***Special Use Permit #2020-00065***  
***765 John Carlyle Street and 1900 Eisenhower Avenue –***  
***Carlyle Block P***

SUP#2020-00065  
765 John Carlyle Street and 1900 Eisenhower Avenue  
Carlyle Block P Amendment

**Attachment #5: Staff Report - North Tower + Podium Final Design Review (DRB) August 27, 2020**

Illustration B: Height of Retail Canopies – Current Proposal

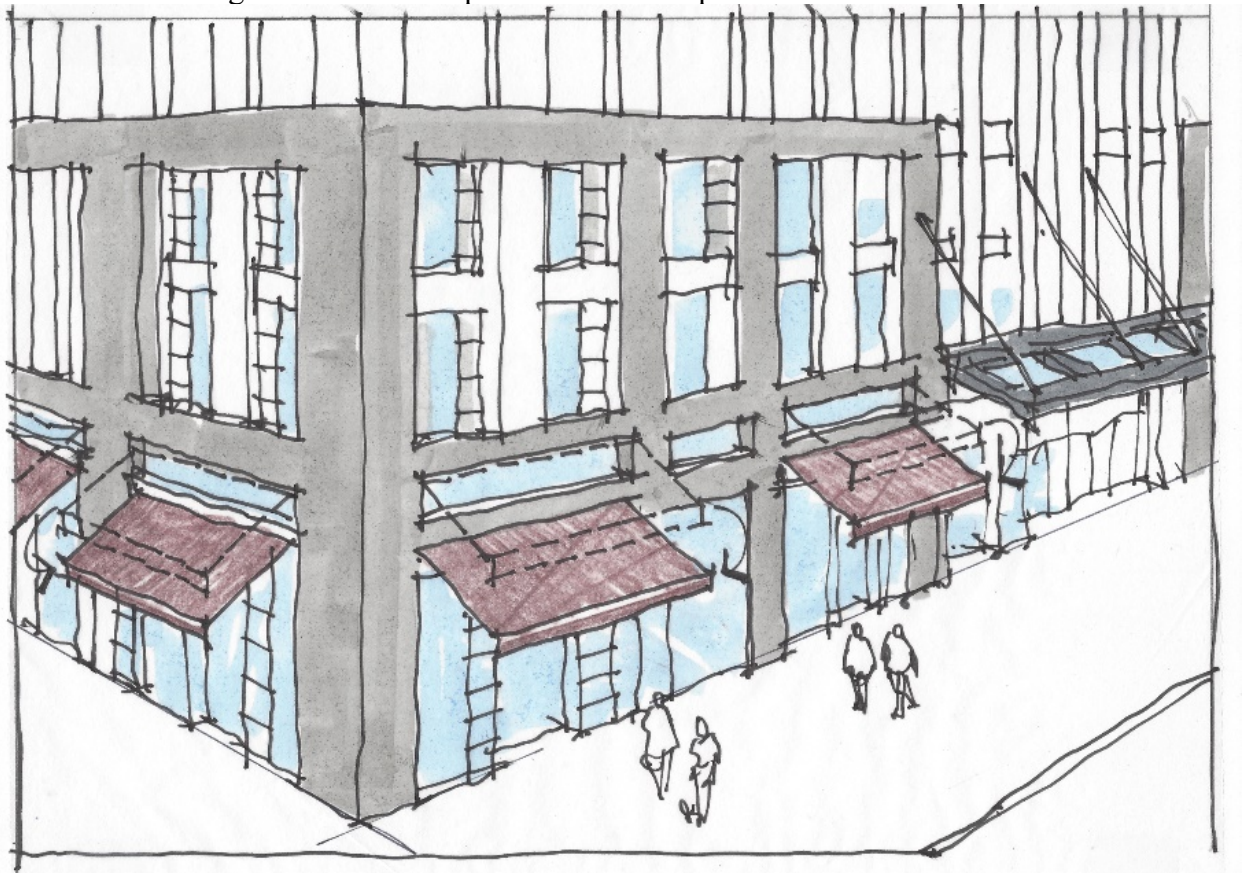
#22 The fabric awnings shown in the current design, while proposed to be fixed on stationary metal frames, still have the appearance of retractable ones in the rendering; further, they appear to be located very high relative to the pedestrian scale. In the interests of scale, weather protection, and opening up the views through the significant transom glass shown, staff suggests lowering the awnings to the next lower building element, a substantial horizontal that separates the storefront glass and transom. An added benefit of this adjustment would be to clearly show the hierarchy that separates these awnings from the metal and glass canopy at the main lobby entrance (Illustration B, below).

Illustration B: Height of Retail Canopies – Staff Proposed Adjustments

Illustration C: Approved Garage Screening at North Tower

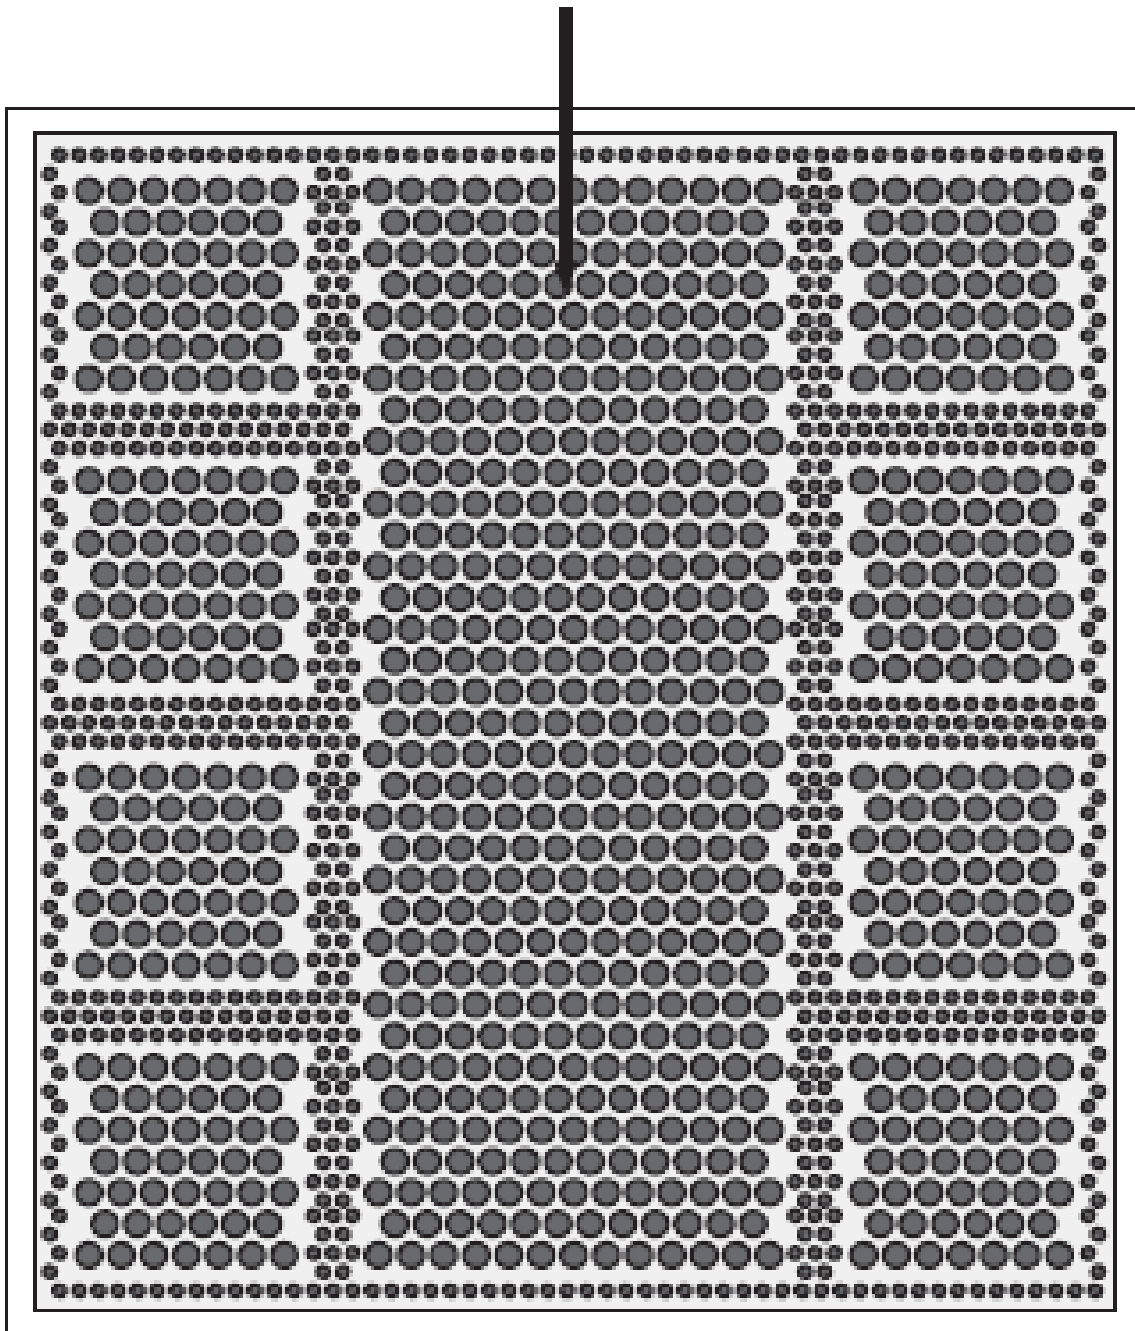
While the previous design was approved with above-grade, naturally-ventilated parking, the screening as approved (and as still proposed for the revised north tower) incorporated a richly-detailed combination of glass, custom louvers, and mullion framing that mitigated the visual impact of the parking (Illustration C, below). Staff does not support the current proposal for the parking screening of the south tower, which proposes to mimic the mullion pattern in the tower above through varying the density of perforations in a large surface of what appears to be flat, perforated metal (Illustration D, below).

**Illustration E: Garage Screening Approved for WMATA VA HQ**

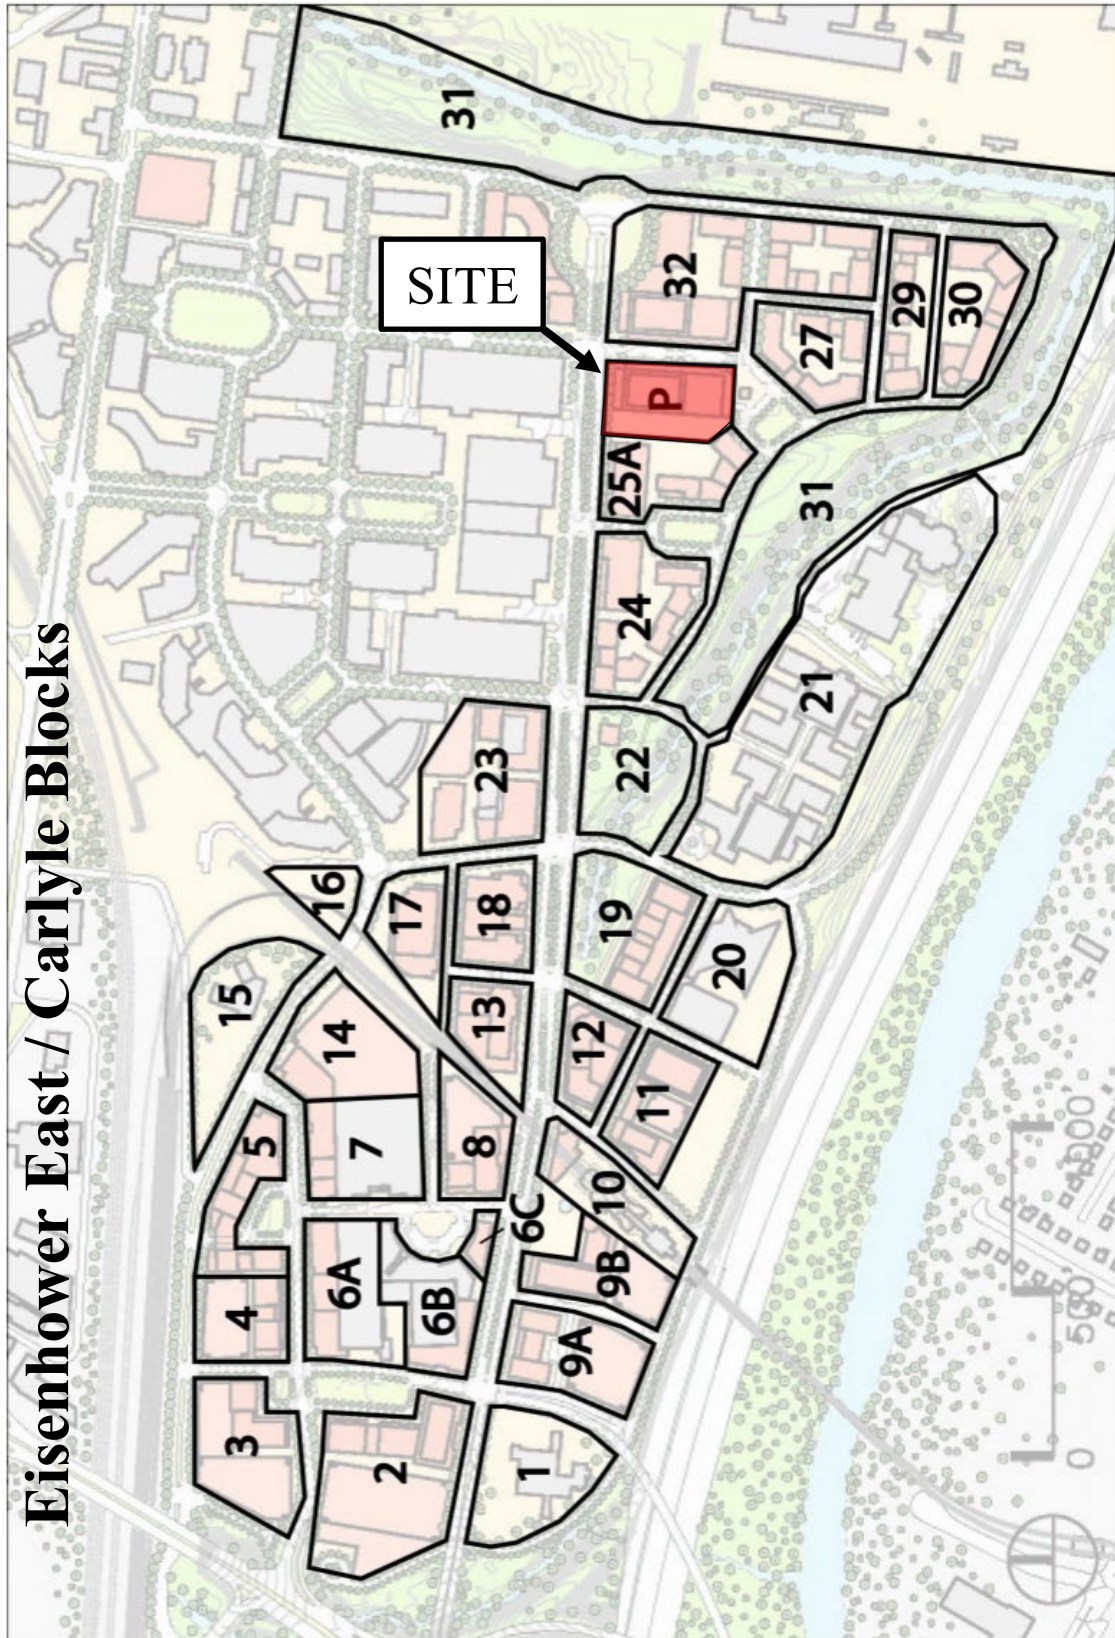
tower, but requires a solution that incorporates a variety of depths, along with a variety of materials (preferably including glass) for some portions of the enclosure. A similar solution was proposed and approved by the DRB for the above-grade parking levels of the WMATA Virginia Headquarters building, currently under construction along Mill Road in Eisenhower East. As in the case of the North Tower, elements of the occupied floors enclosure system above are carried down through and incorporated into, the parking screening system (Illustration E, below).

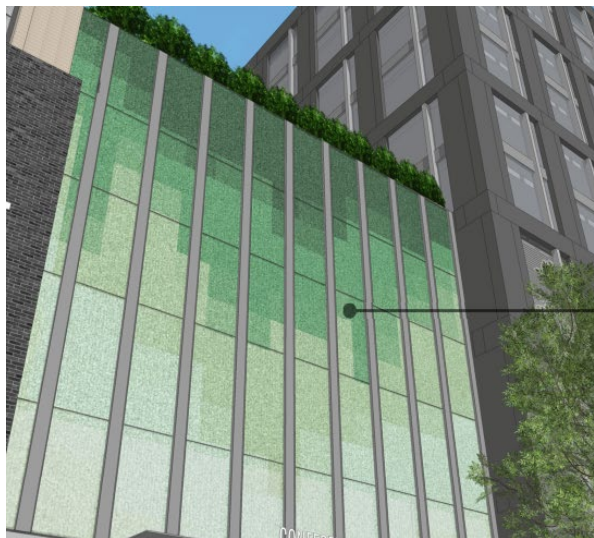
Site constraints and previous approvals dictate that parking ascend above grade on Block P. Never the less, the proposed office tower will be full story shorter than the original approval, as the applicant has removed one (1) level of structured parking, as intimated above. Generally speaking, the screening at the podium level, P2 – P5, is bifurcated into either glazing, or metal systems. More specifically, glazing is used to conceal the first two levels to the parking, which is setback slightly from the retail base in plan, from the retail level,

while the remaining upper floors (P4 – P5) are concealed by a perforated metal panel, similar to the approve design for the south tower. This design uses various systems of aluminum/steel to recall the typical expression of a window. However, as intimated, the accompanying detail requires reconciliation.

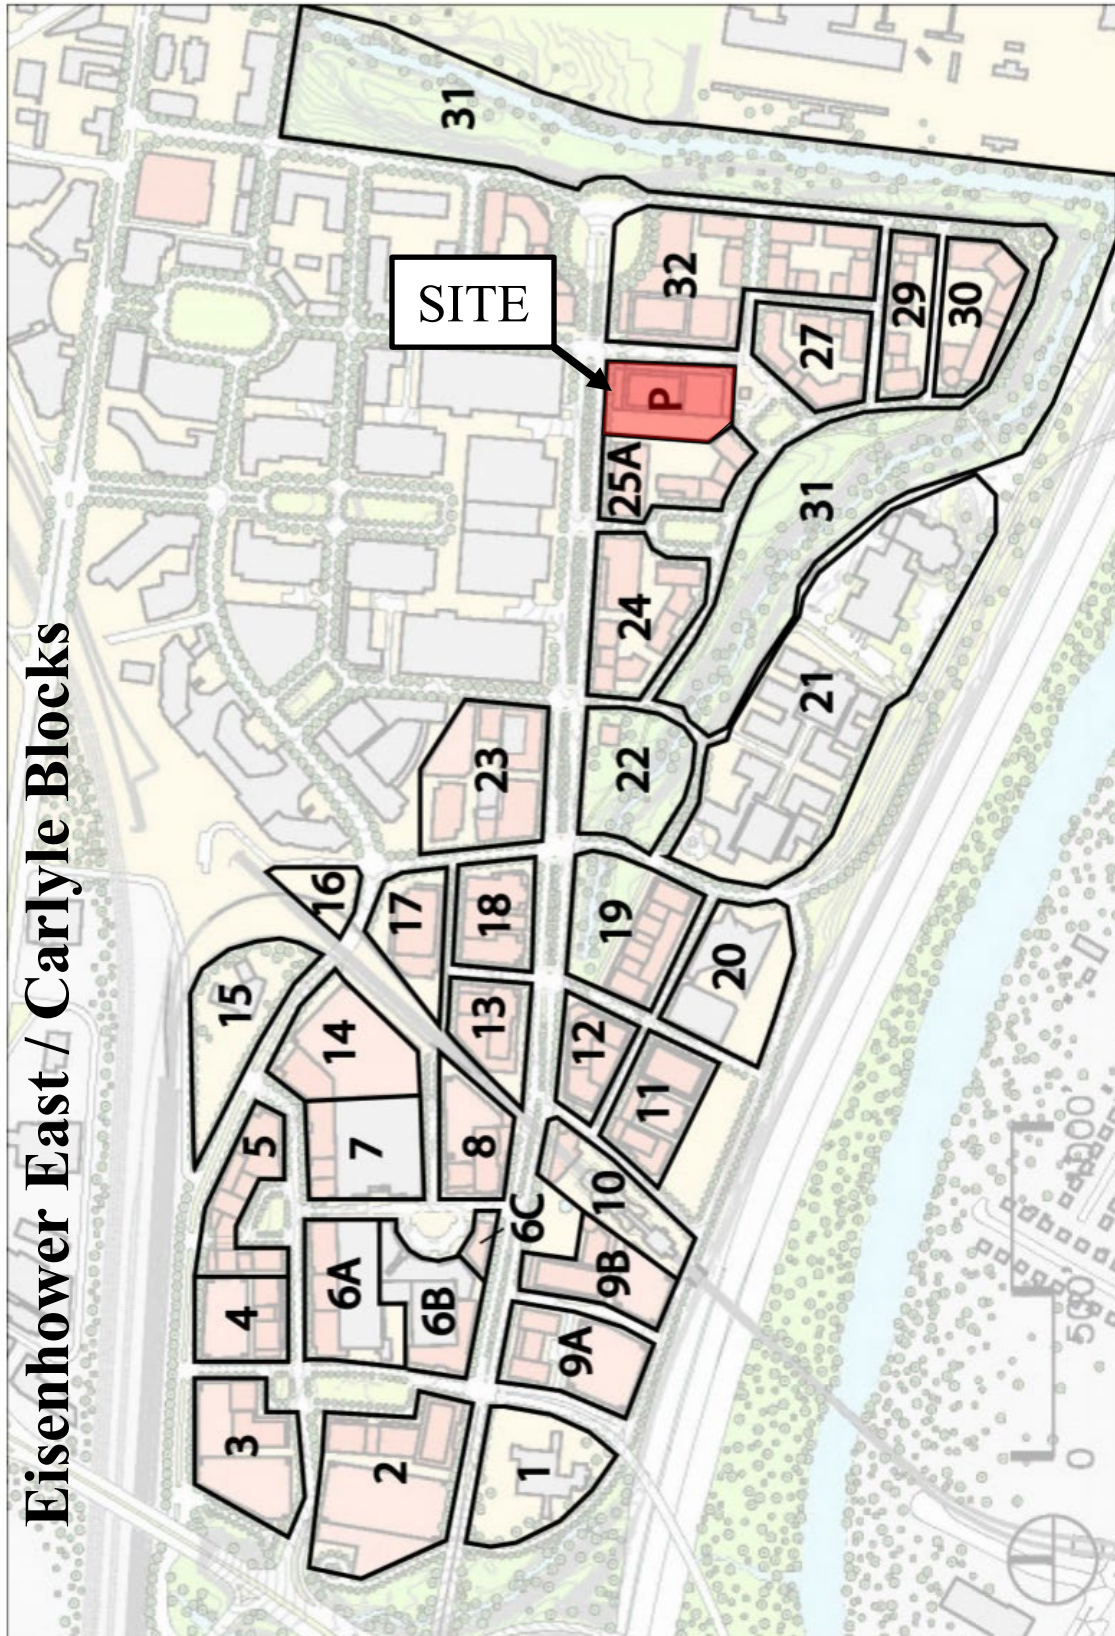
The podium level of block P, which is being pursued under this final submission, is a 5-level retail and parking structure that anchors both the north and south towers. Generally speaking, staff are in agreement with the general architecture and expression, however as intimated previously and in the South Tower's report, the use of the dark brick to create a strong, readable base, is not successfully integrated into the overall architecture. The brick base should be used at

the human scale (1<sup>st</sup> floor only) level to create enough contrast with the materiality of same above, while still reading as a strong, base-defining architectural element.
